**SOMERS PLANNING BOARD
AGENDA
SEPTEMBER 9, 2015
7:30 P.M.**

- 2. GRANITE POINTE FINAL SUBDIVISION [TM: 27.05-3-2,5]**
Application for Final Subdivision Approval, Wetland, Steep Slopes, Tree Removal and Stormwater Management and Erosion and Sediment Control Permits. The property is located on the east side of Route 118/202, adjacent to the Amawalk Reservoir and is located in an R-40 Zoning District. Property is owned by Suelain Realty, LLC. for the development of 23 lots in a Cluster Subdivision.
Consideration of a Draft Resolution of Final Subdivision Approval.

Our office was retained to review the Subdivision Plans, the Stormwater Pollution Prevention Plan (SWPPP) and project correspondence. The following is a summary of the findings of our investigation. Our ability to thoroughly review the latest project information was severely limited by the time allowed once we had received the project documentation. Accordingly, this might be considered a snapshot of the bigger picture items of the project's design. A detailed review would not have been possible given the time allotted.

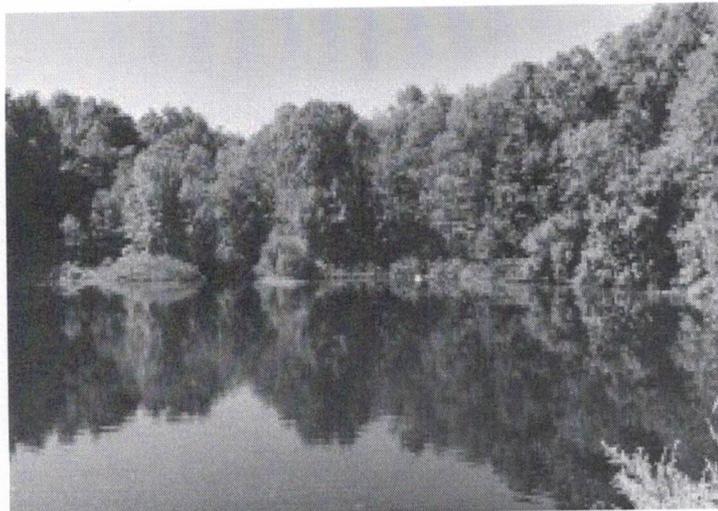
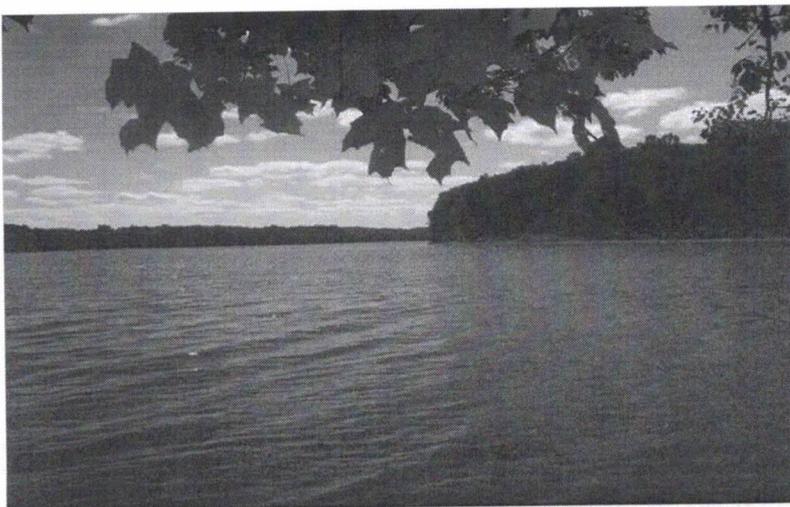
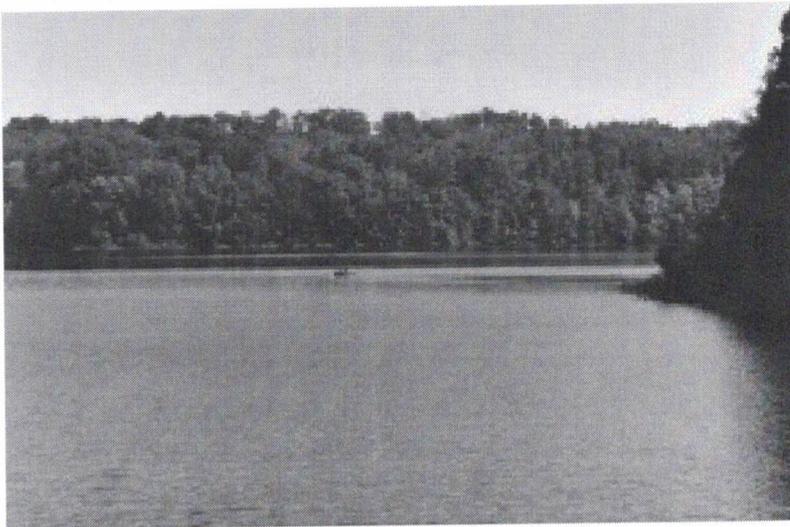
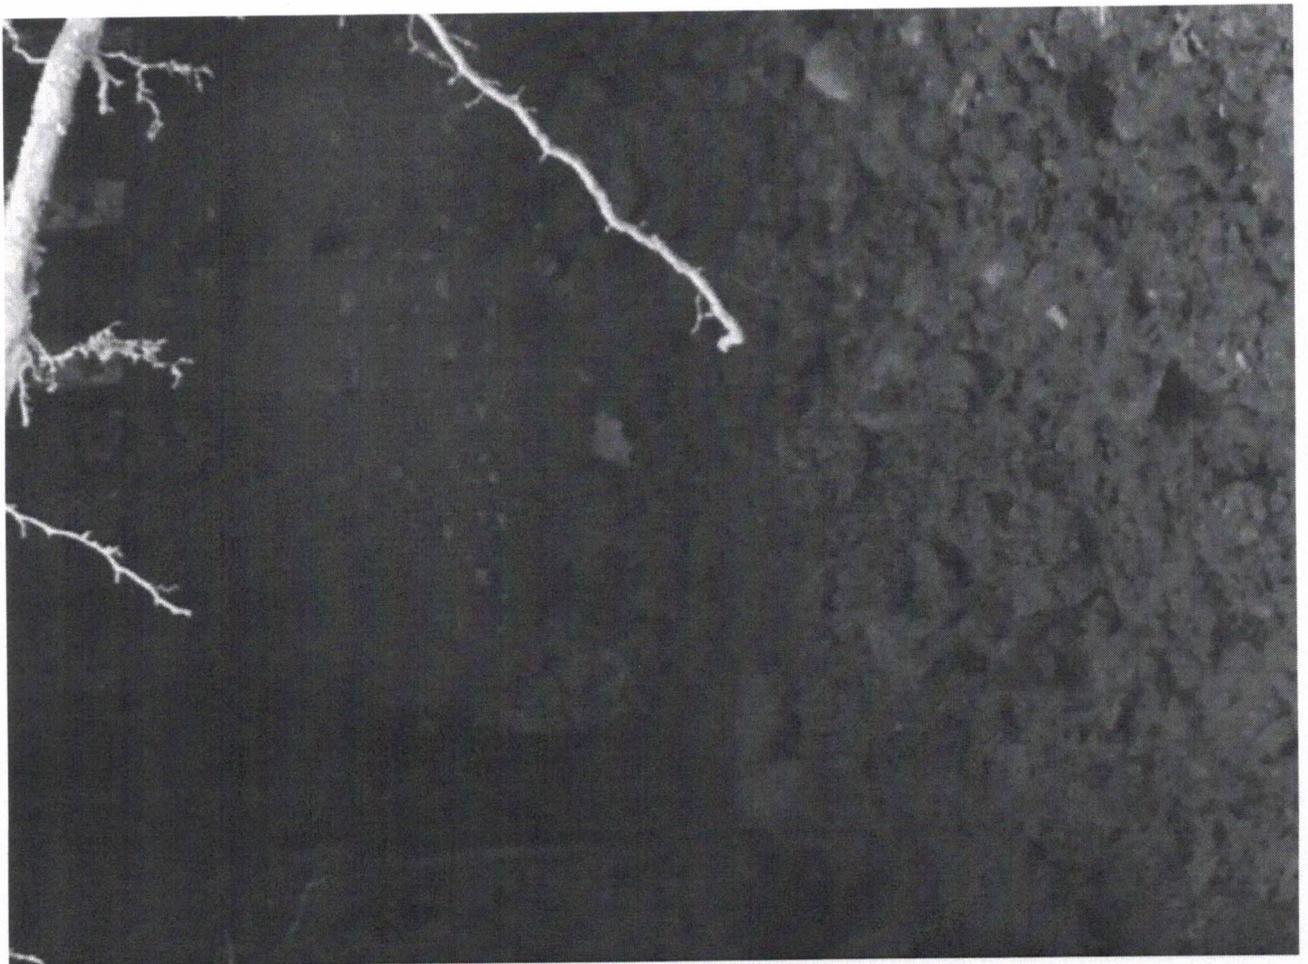
The DEP limiting distance must begin at a minimum from the spillway level and not from a shallower water level the applicant is using to bring his project out toward the water. However, even such spillway elevation level does not take into account powerful wind action forcing wave action high above the spillway level during extreme weather events we have witnessed and which make a 100-year storm event likely.

Further according to the DEP supervisor for Amawalk Reservoir, **the Amawalk Reservoir dam crest level is 411.0 feet above sea level. The Granite Pointe housing subdivision project**, which seeks final approval nearly three decades following its original application [rendered null and void by former DEP legal action against the Town of Somers], **must be held not just to the spillover level, but to the dam crest level.** As above noted, the spillover level denotes a calm water surface. When the next catastrophic storm or 100-year event hits the banks of Amawalk Reservoir, water levels will rise high above the calm spillover level and possibly even higher than the dam crest level of 411.0 feet above sea

level. The Granite Pointe project must be held to the highest DEP water mark for Amawalk Reservoir, 411.0 feet above sea level.

If the Granite Pointe project is not using, at the minimum, the spillway elevation level as the beginning point of the DEP limiting distance, the Granite Pointe project is in direct violation of DEP Watershed Rules & Regulations.
